# CMD 25-H9.REF4 CNSC Staff Submission

## Reference Package 4 for CMD 25-H9 CNSC Staff Submission on Denison Mines Licence Application to Prepare Site and Construct the Wheeler River Project

Annex 6

Federal Indigenous Review Team (FIRT) Review of Denison Responses to Information Requests (IRs) and Supporting Documents Received February 10, 2024

**Figure 2-9: Bat Species Observed within the Wildlife Study Areas**

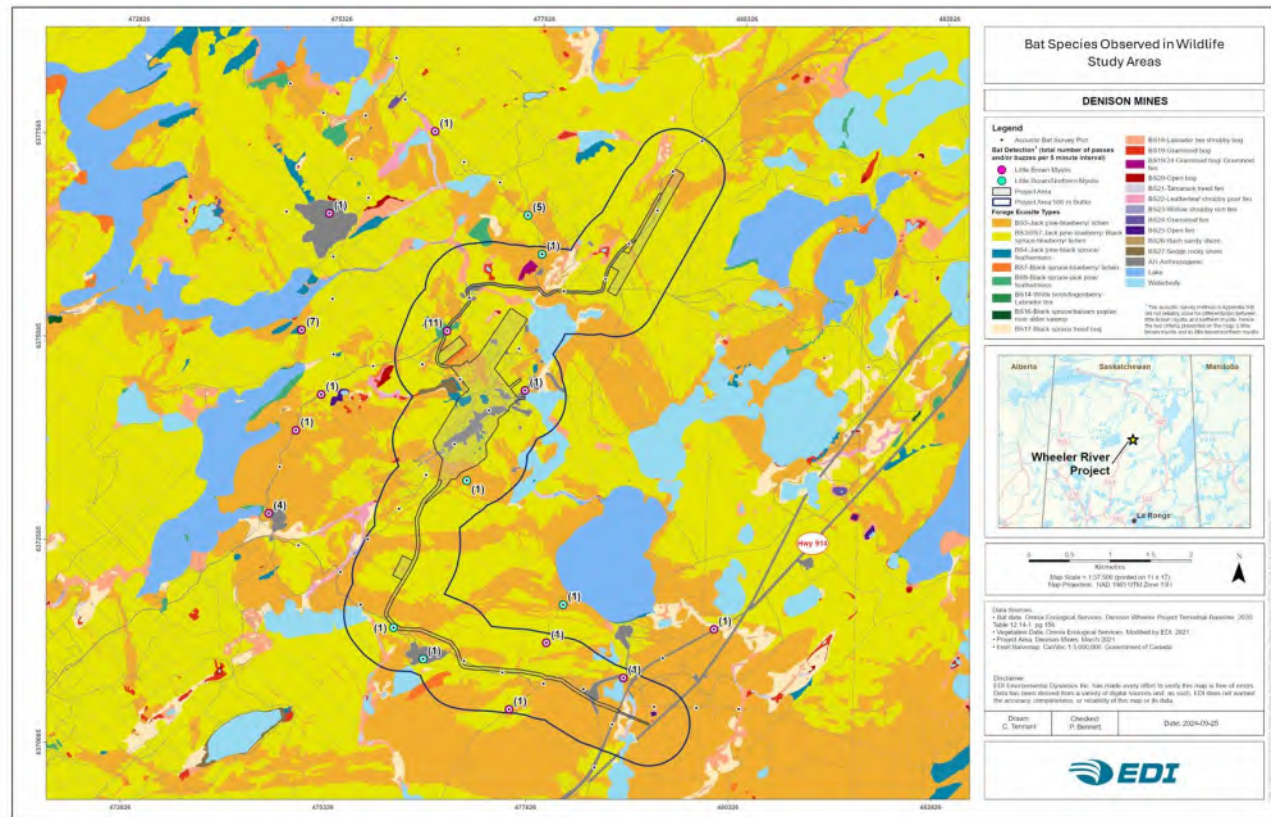
**Commented [A1]:** Update the dots
